Re: Traffic Noise Assessment Cover Letter  
2710 Draper Avenue, Ottawa ON  
GWE File No.: 17-059- Cover Letter- July 24 2019

Following our submission of a traffic noise study for the proposed residential subdivision located at 2710 Draper Avenue in Ottawa, Ontario (ref. Gradient Wind report #17-059 - Traffic Noise Final R2, dated November 2, 2018), this brief letter addresses comments from the City of Ottawa regarding the proposed noise barrier located within the rear yard of Block 11.

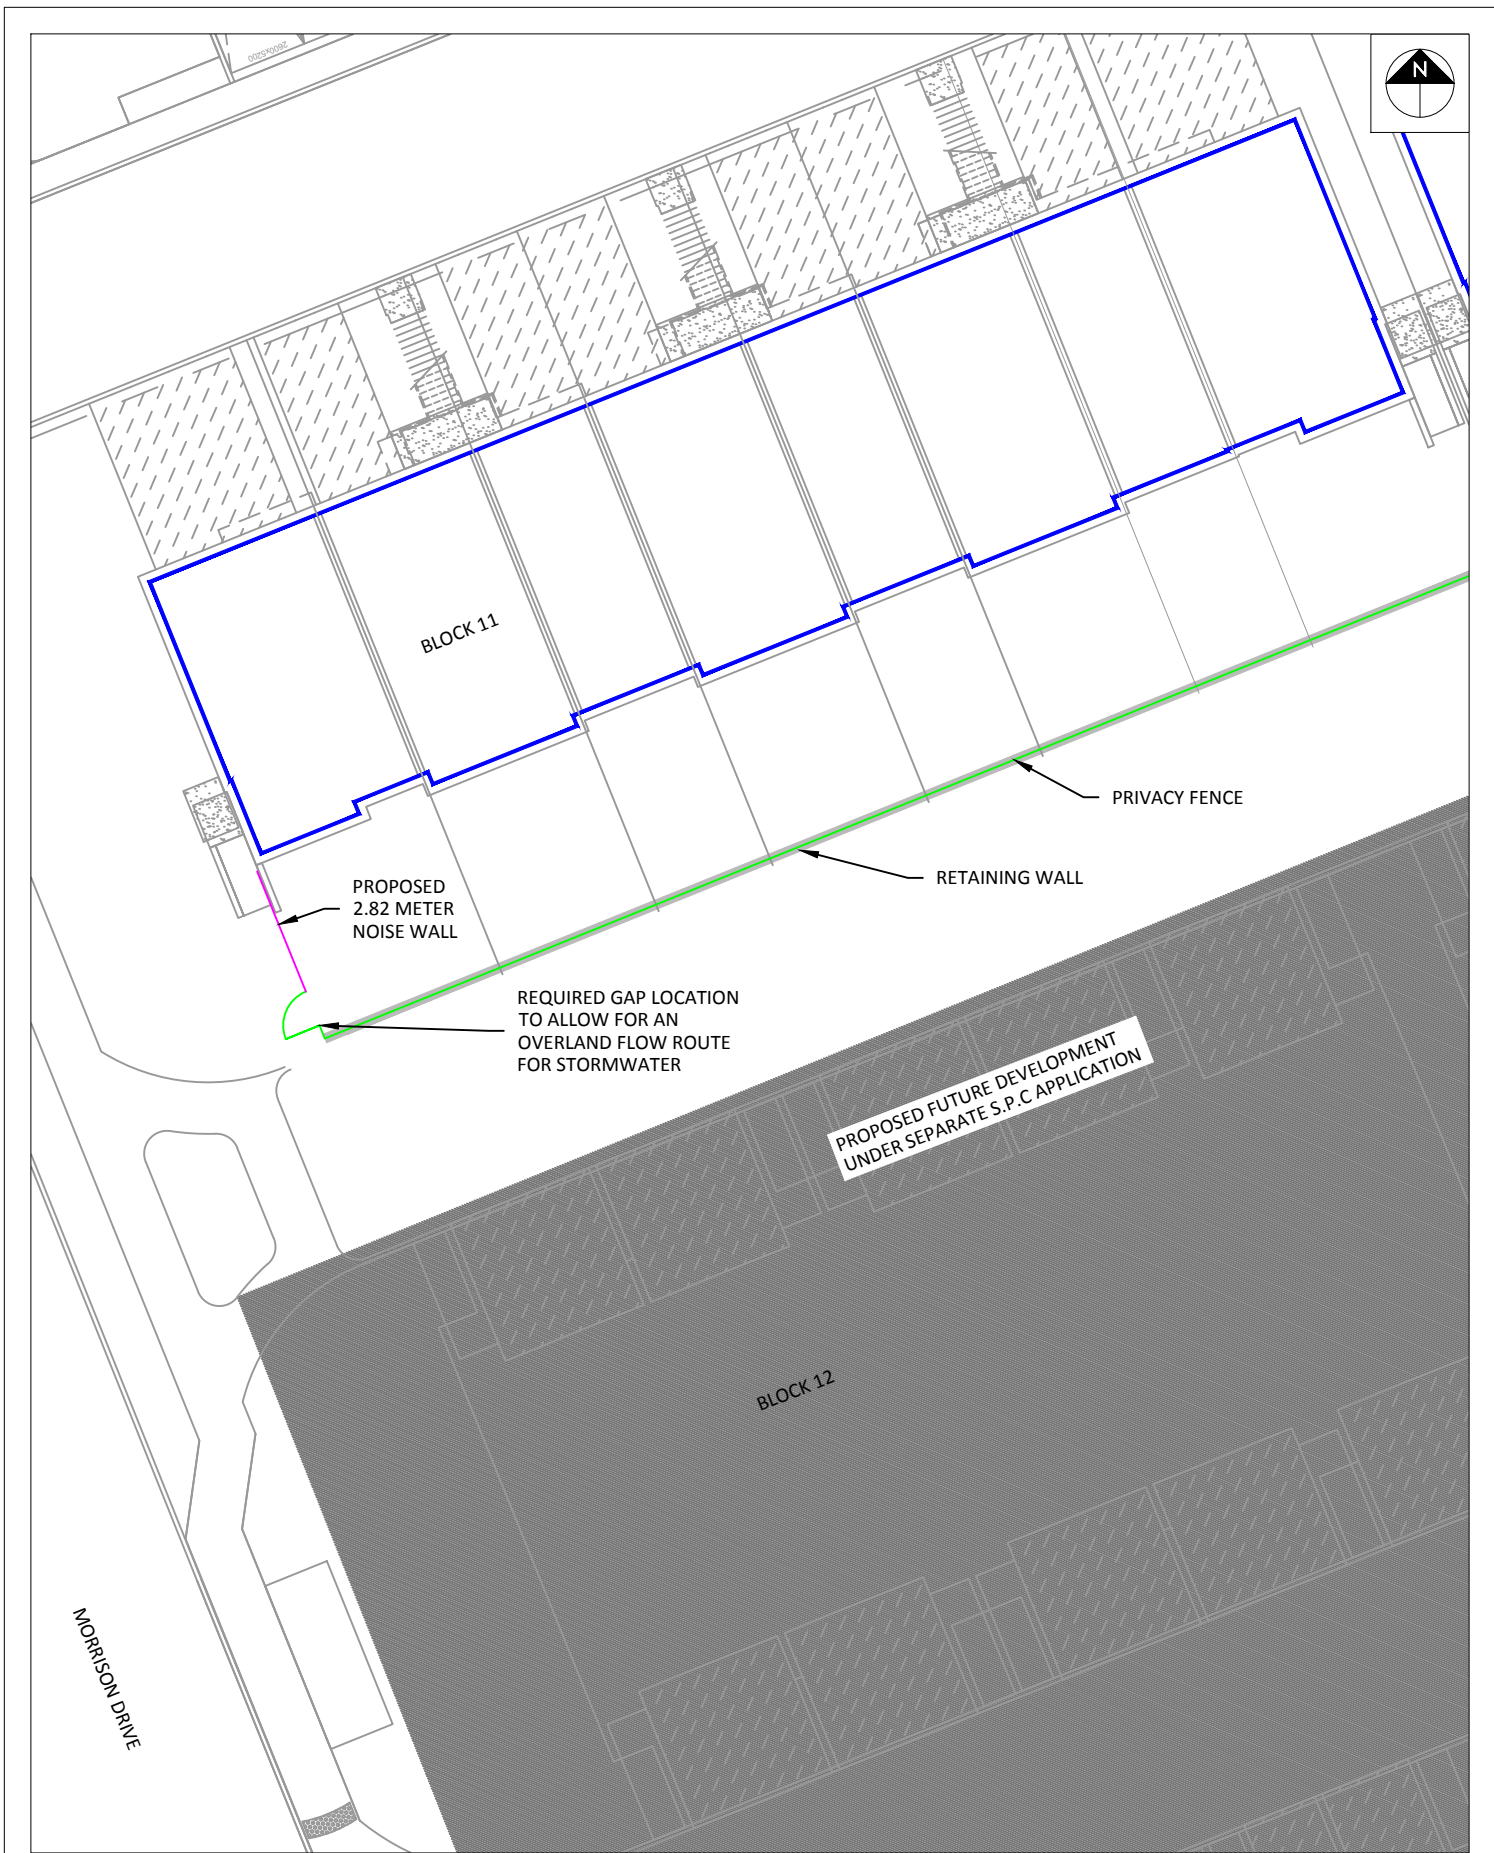
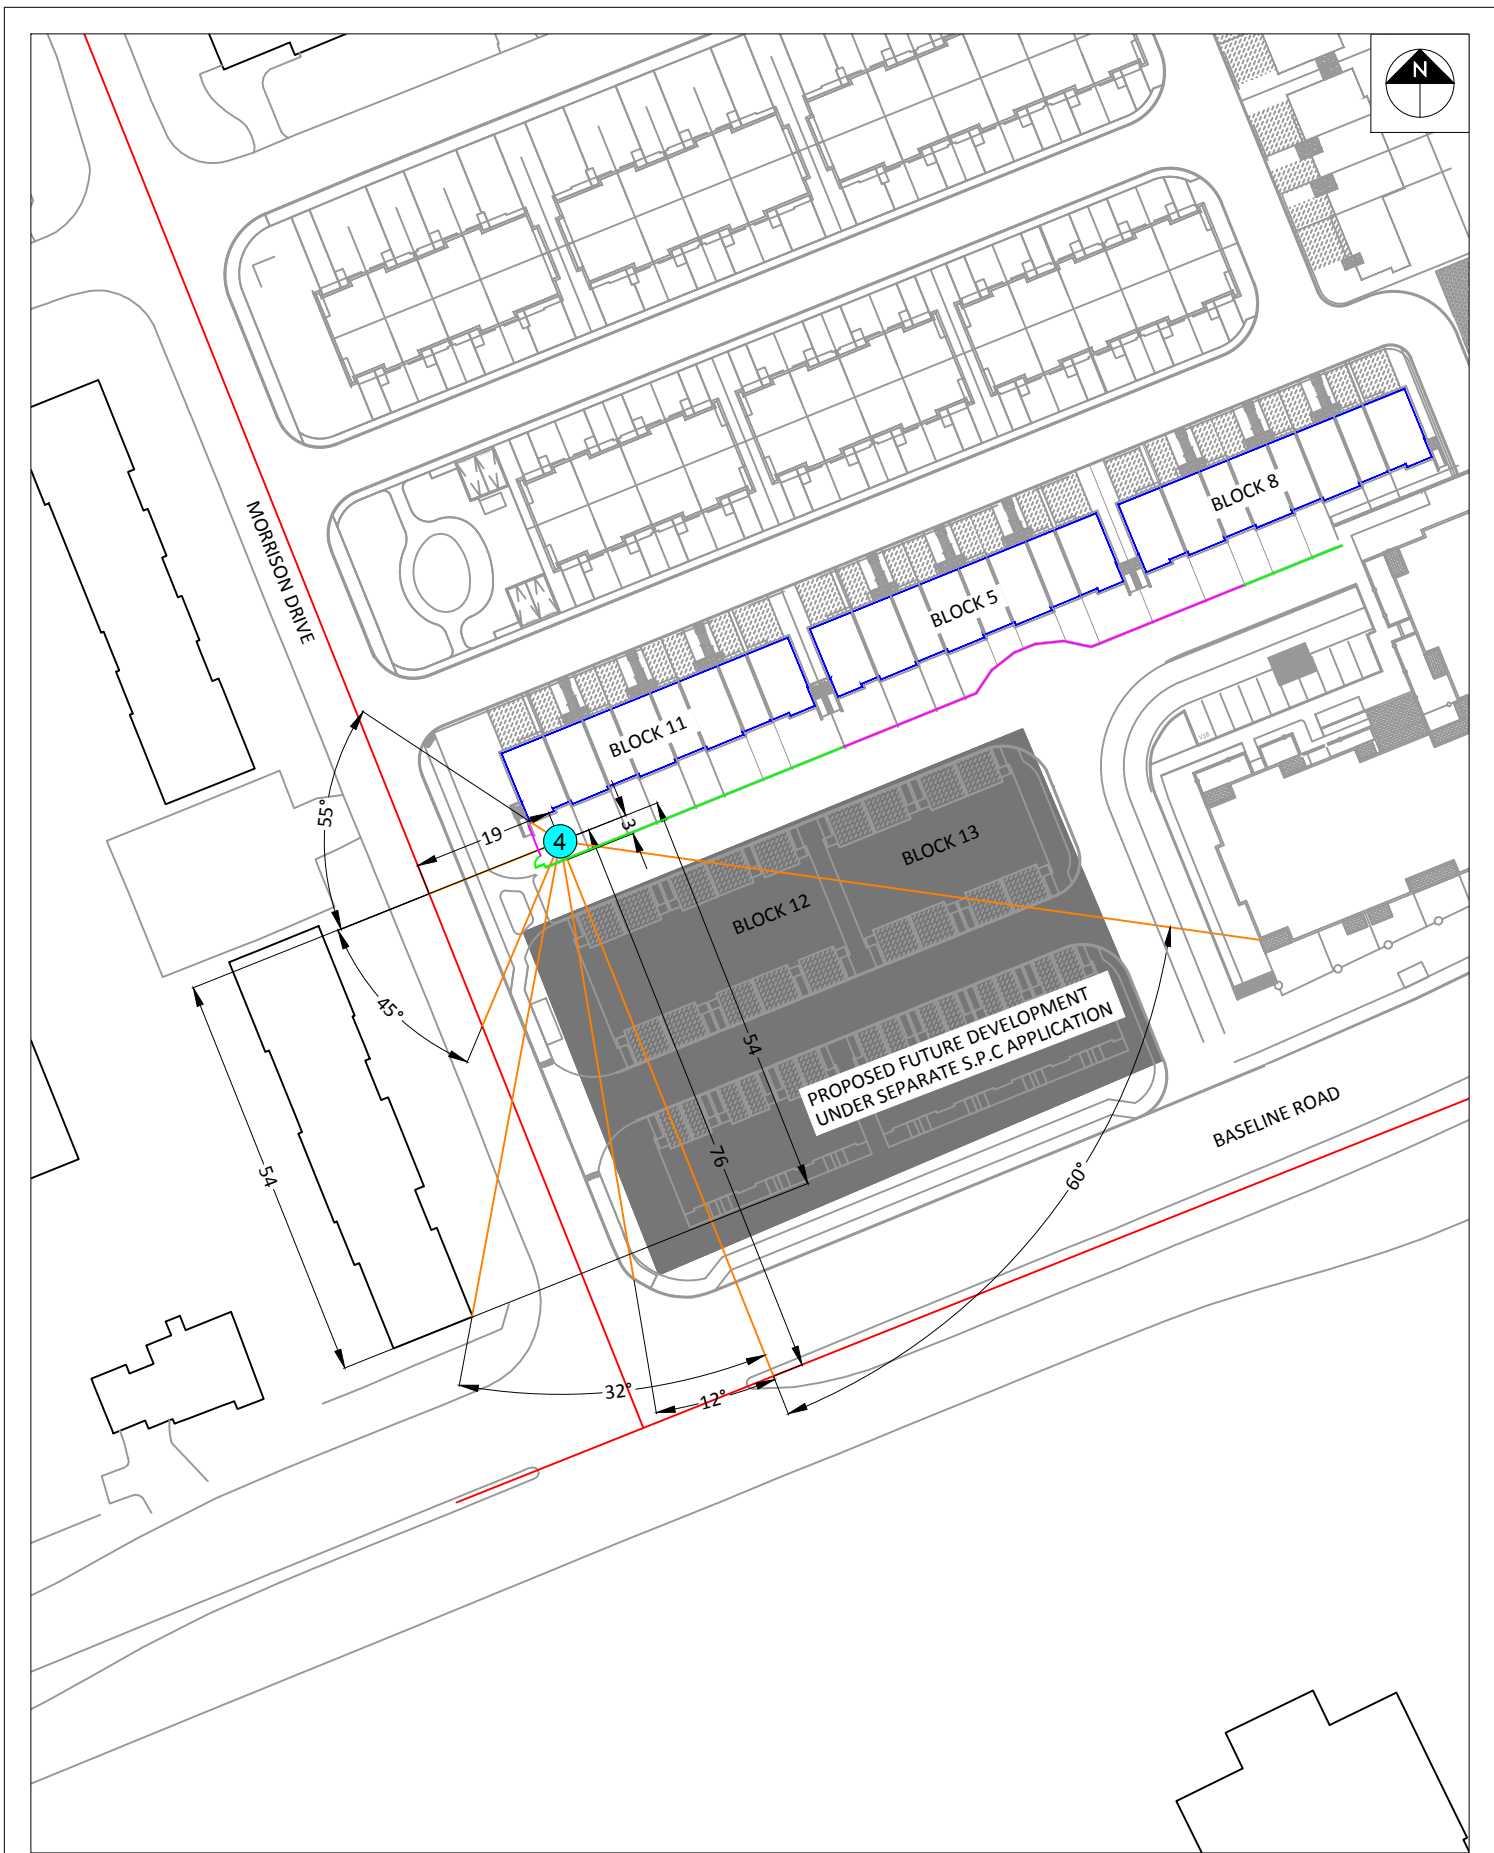
1. *As per the Traffic Noise Assessment prepared by Gradient Wind Engineering Inc. dated November 2, 2018 a 2.82m noise barrier is located within the rear yard of Block 11. Rear yard drainage and the rear yard overland flow route is impacted by the location of this proposed noise barrier. No details have been provided on the plan. As per the Environmental Noise Control Guidelines (January 2016) acoustic barriers should have no gaps or opening in a noise barrier. If a gap or small opening is being proposed to accommodate rear yard overland flow this would be considered a deviation requiring cover letter to be submitted from the noise consultant for review and approval stating the deviation, the reason/justification for the deviation and further analysis completed with a gap modelled within the noise barrier. Noise barrier details are required be provided on the plan.*

**GWE Response:** Without the wall along the west property line of Block 11 sound levels at the rear yard will be 59 dBA assuming Phase 3 massing or a noise wall to the south, see Figure 1. The STAMPSON output file for this calculation is attached to the end of this letter and Figure 2 illustrates the source to receiver distances and angles. The primary sound source at this location is roadway traffic along Morrison Drive situated to the west of the site. According to the City of Ottawa's Environmental Noise Control Guidelines (ENCG) as well as the Provincial Environmental Noise Control Guidelines (NPC-300), the sound level criterion for outdoor living areas is 55 dBA, which applies during the daytime (07:00 to 23:00). When noise levels exceed 55 dBA but are within 60 dBA, mitigation is recommended to reduce noise levels where technically and administratively feasible to acceptable levels at or below the criterion.

Gradient Wind has considered the requirements of easement access and overland drainage with the project architect and civil engineer. Given the requirement for access to the rear yards via a gate, or similar opening, a noise wall spanning the entire west side of the rear yard of Block 11 is unfeasible at this location. Any gate in an acoustic wall would significantly reduce the effect of the wall on the west side of Block 11. In addition to a gate the overland flow of the site slopes down toward the proposed wall and small gaps would be required to allow proper drainage. While small gaps of less than 20 cm at the base will not have a significant impact<sup>1</sup> on the performance of a noise wall, the combined effect further reduces the acoustic properties of the noise wall at this location. Since noise levels without the wall are less than 60 dBA this section of the wall can be deleted. Figure 1 outlines the location of the 2.82 meter noise wall in addition to the section of the wall replaced by a gate.

Great Wise is also proposing a third Phase of townhomes under a separate application. Should construction of this Phase begin prior to occupancy of Block 11, the portion of wall along the south property line would not be required and can be substituted with privacy fencing, as illustrated in Figure 3.

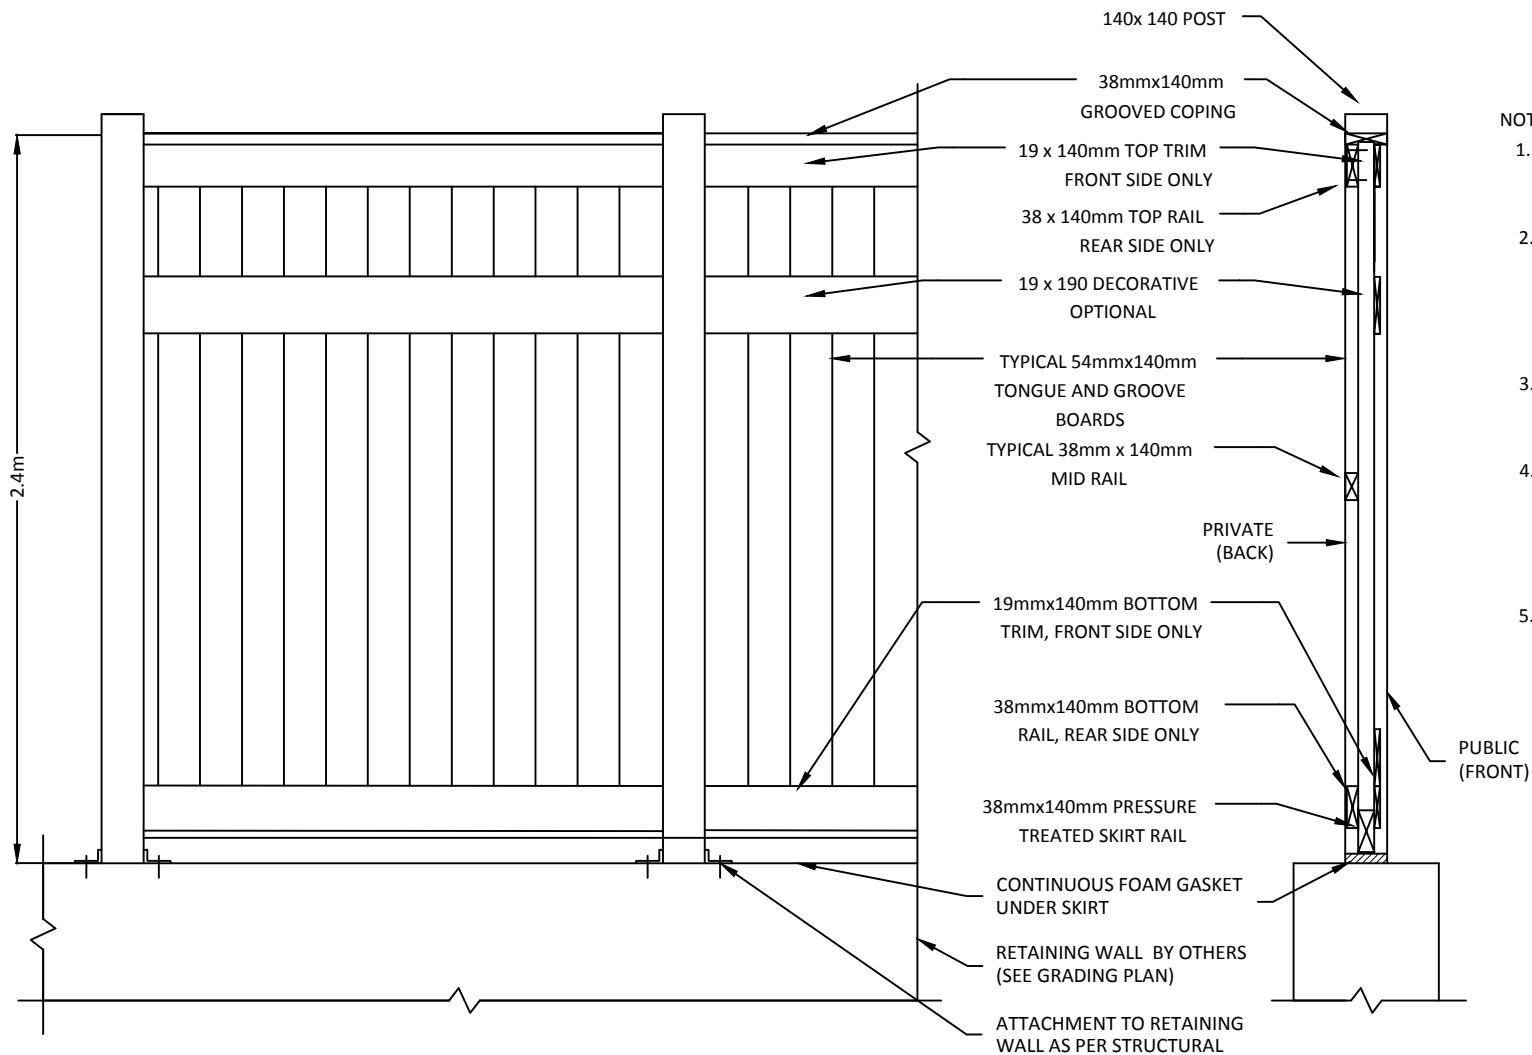
Subsequently since submitting our addendum letter dated May 31, 2019, the City in their comment letter dated July 3, 2019 have since asked for barrier details and modified warning clauses as related to comments 41 and 42.

Below is the modified warning clause for Block 11 and conceptual details of the noise barrier are provide in Figure 4. The structural details of the noise wall will need to be reviewed by a qualified structural engineer prior to construction of the wall. Shop drawing of the noise wall should be provided to Gradient Wind for approval prior to construction.
